Notification to the customers

Since October 1st 2021 Magic Xtals ceases accept new orders for the following OCXO models: MXO37/8, MXO37/14, MXO37H/14, MXO37/8PS, MXO37H/14PS and MXO37/14PS. These models will be considered obsolete and replaced by modern equivalents as per the table below.

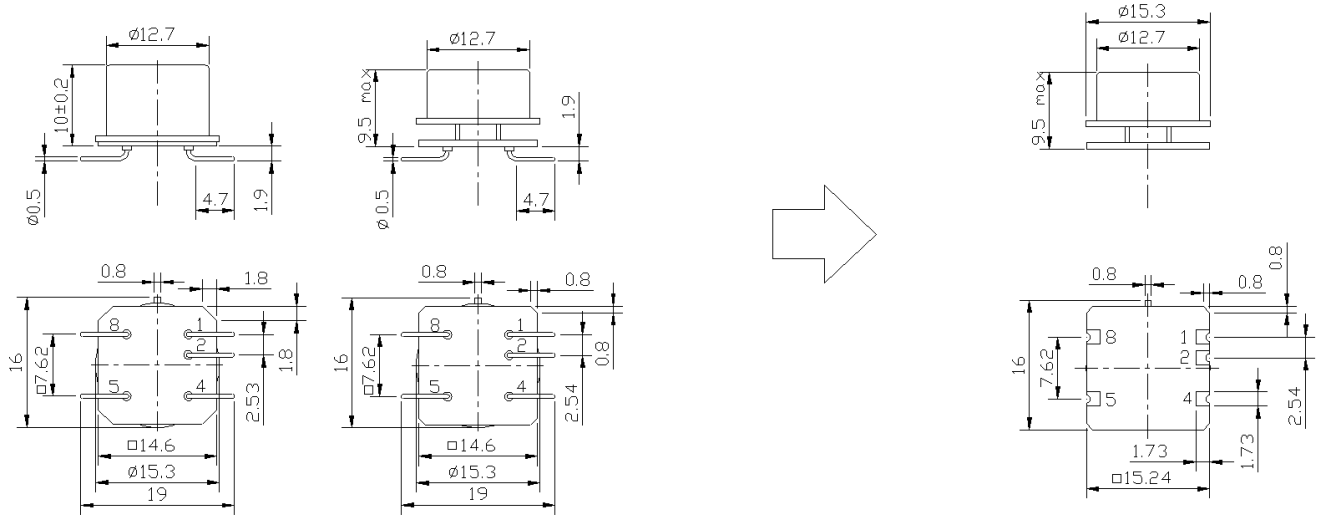
The main reason for the replacement is improvement of reliability of the OCXOs for more perfect cleaning after their assembling due to 1 mm gap between the resonator and the PCB, as well as for excluding of the frangible bent legs in the SMD version. Moreover, the modern models provide much better frequency stability owing to usage of advanced oscillator circuitry and have only 9.5 mm height.

Obsolete OCXO	Modern OCXO
MXO37/8-	MXO37/8P-
MXO37/8S- MXO37/8PS-	MXO37/8PS-T
MXO37/14-	MXO37/14P-
MXO37/14S- MXO37/14PS-	MXO37/14PS-T
MXO37H/14-	MXO37H/14P-
MXO37H/14S- MXO37H/14PS-	MXO37H/14PS-T

MXO37/14
MXO37H/14

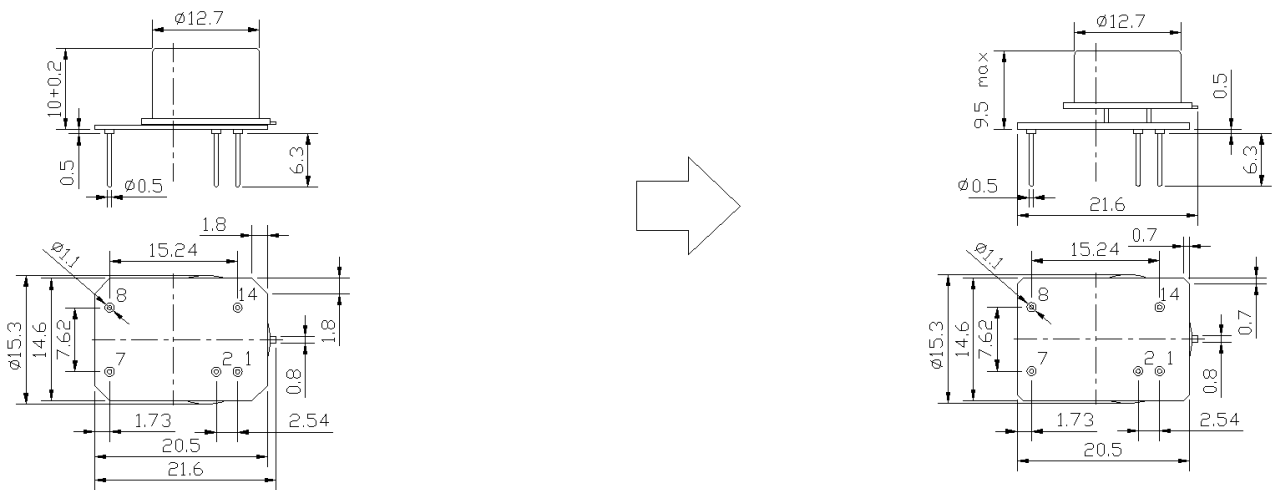
replaced with

MXO37/14P
MXO37H/14P

MXO37/14S
MXO37H/14S

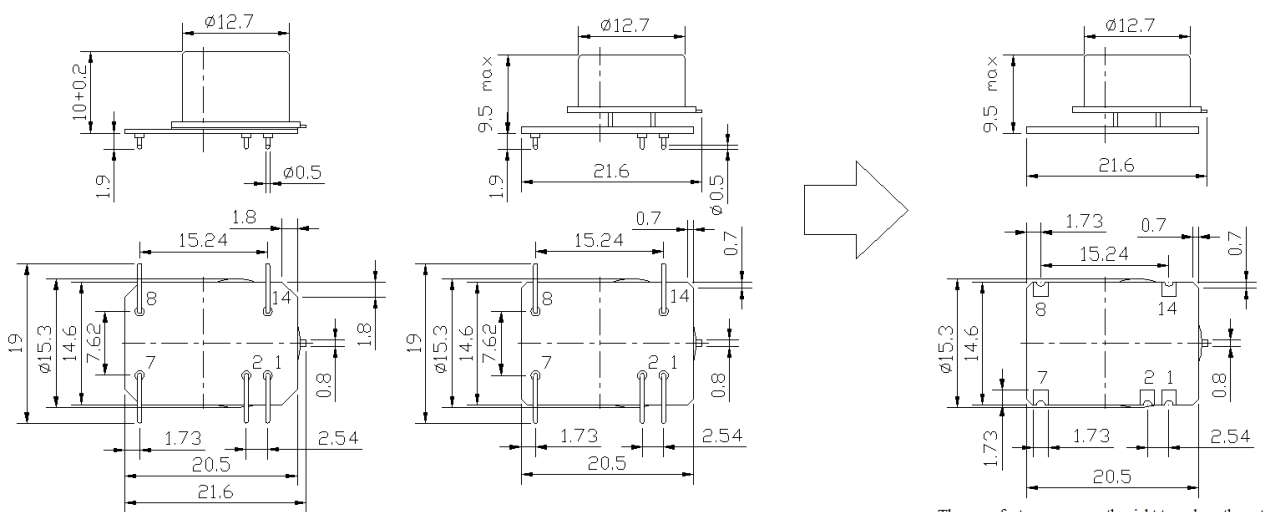
replaced with

MXO37/14PS-T
MXO37H/14PS-T

MXO37/14PS
MXO37H/14PS
